[Docket No. FAA-2005-22026; Directorate Identifier 2005-SW-05-AD; Amendment 39-14210; AD 2005-16-05]

Airworthiness Directives; Robinson Helicopter Company Model R-22 Series Helicopters

ACTION: Final rule; request for comments.

Figure 1

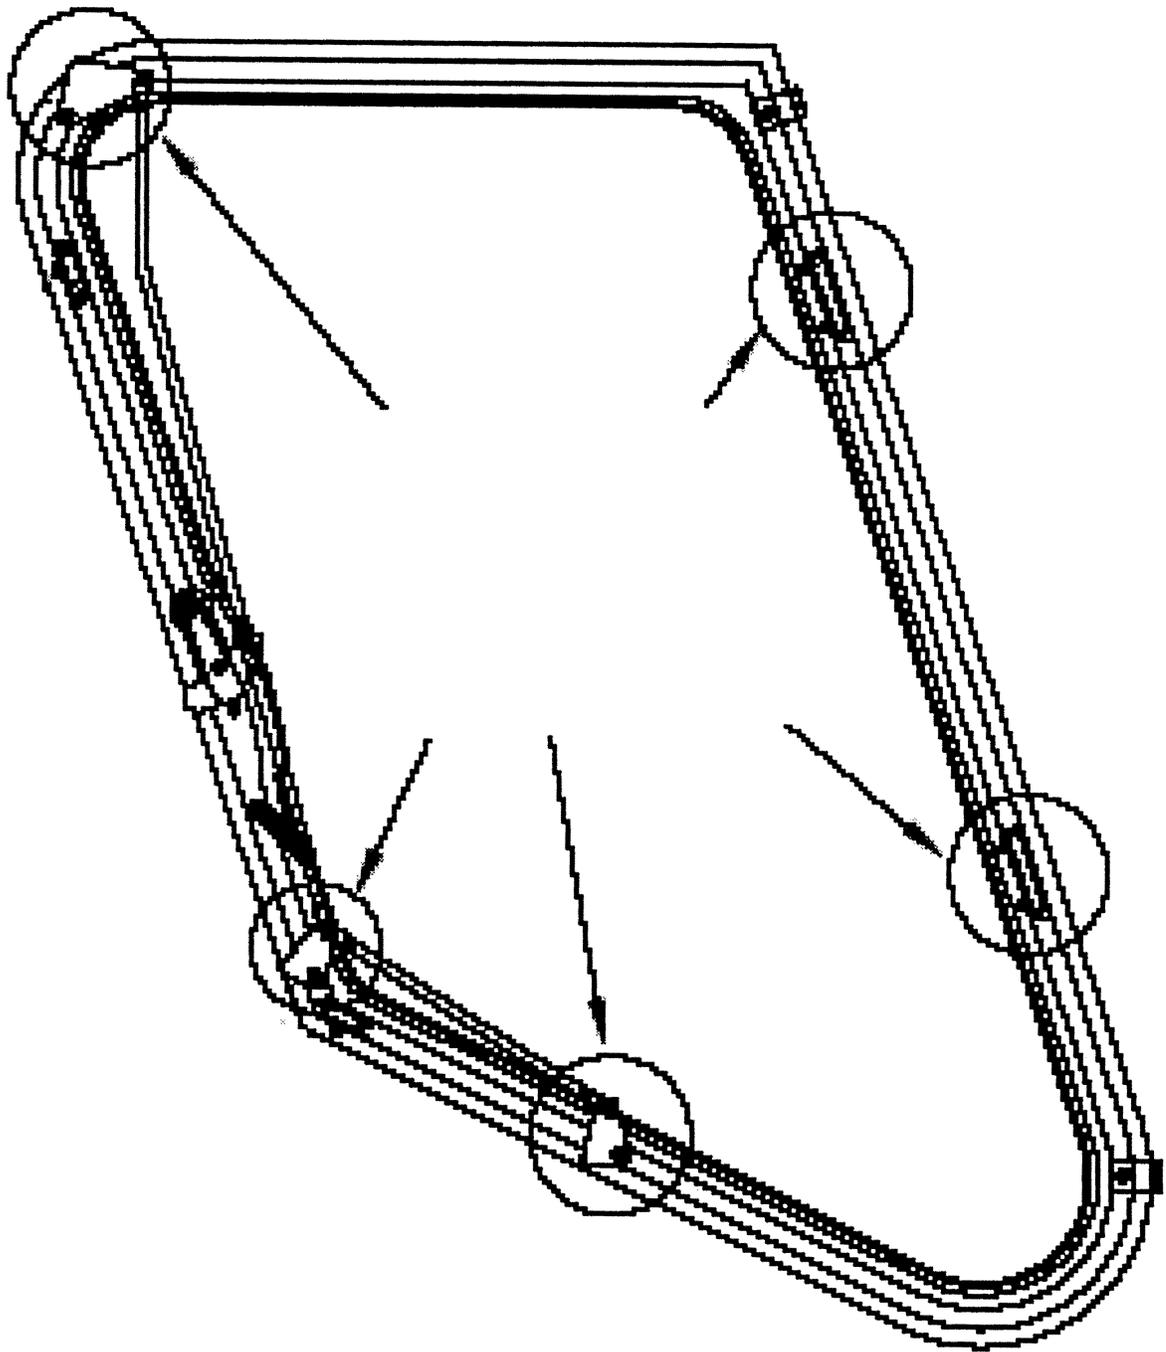
(1) Visually inspect each pilot and copilot door assembly integral frame for a crack in the locations depicted in Figure 1 of this AD. If a crack is found, before further flight, replace the cracked door assembly, part number (P/N) R-22-101-51 or P/N R-22-101-53 (left-hand door assembly), or P/N R-22-101-52 or P/N R-22-101-54 (right-hand door assembly), with an airworthy door assembly. If you use door assembly, P/N R-22-101-51 or P/N R-22-101-53 (left-hand door assembly), or P/N R-22-101-52 or P/N R-22-101-54 (right-hand door assembly) as the replacement, then install it in accordance with Tech-Tool Plastics, Inc. Installation Instructions TTP-1R, Revision A, dated November 21, 1997, and with the sections titled "Door Weather Seal Installation" and "Cotter Pin Installation" in Tech-Tool Plastics, Inc. Service Bulletin No. TTP2005-01, Revision A, dated February 1, 2005 (SB).

(b) After accomplishing the inspections in paragraphs (a) through (a)(2)(ii) of this AD, at intervals not to exceed 100 hours time-in-service, visually inspect each pilot and copilot door assembly integral frame for a crack in the locations depicted in Figure 1 of this AD.

(c) If a crack is found, before further flight, replace the cracked door assembly, P/N R-22-101-51 or P/N R-22-101-53 (left-hand door assembly), or P/N R-22-101-52 or P/N R-22-101-54 (right-hand door assembly), with an airworthy door assembly. If the replacement door assembly is P/N R-22-101-51 or P/N R-22-101-53 (left-hand door assembly), or P/N R-22-101-52 or P/N R-22-101-54 (right-hand door assembly), then install it in accordance with Tech-Tool Plastics, Inc. Installation Instructions TTP-1R, Revision A, dated November 21, 1997, and "Door Weather Seal Installation" and "Cotter Pin Installation" sections of the SB.
